## REMARKS/ARGUMENTS

Applicant responds herein to the Office Action dated July 31, 2003. A Petition for Extension of Time and the fee therefor are enclosed.

FIG.5

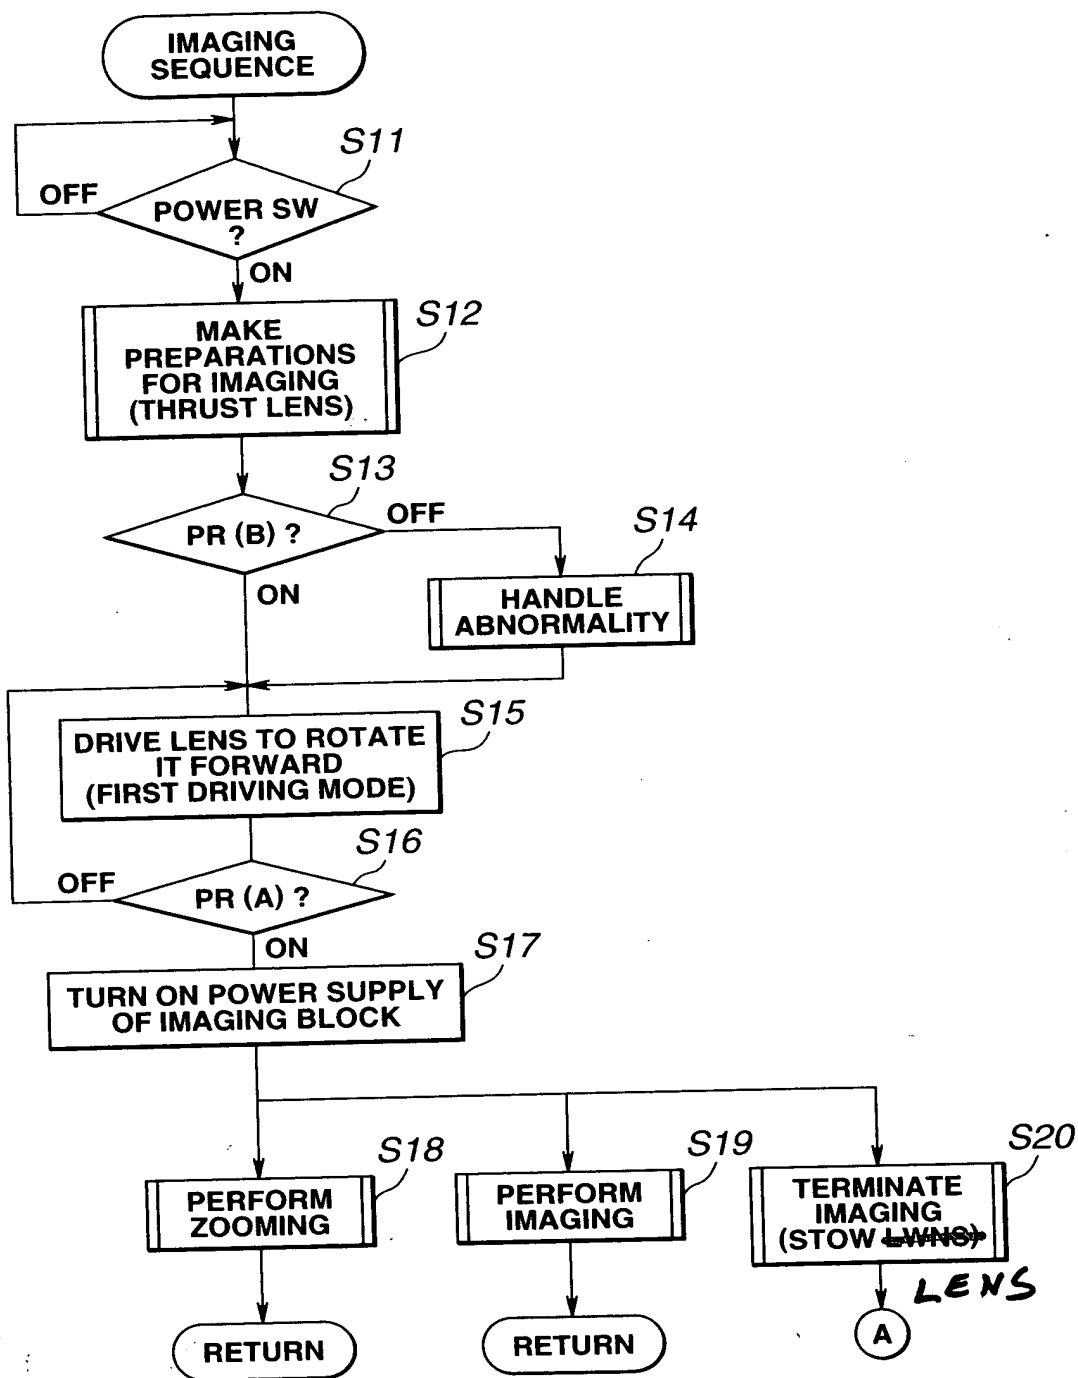
In addition, Figure 5 has been amended to correct a typographical error therein. Reconsideration and withdrawal of all of the objections to the specification, drawings and to the Abstract is earnestly solicited.

**FIG.9**

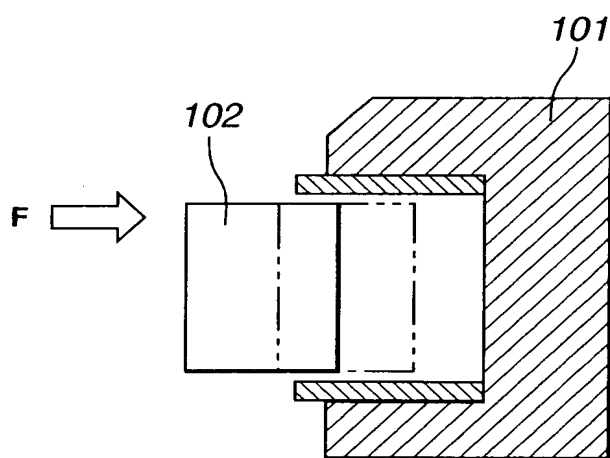
As requested, the applicant has properly identified Figures 9-12, by appending thereto the legend "PRIOR ART".

PRIOR ART
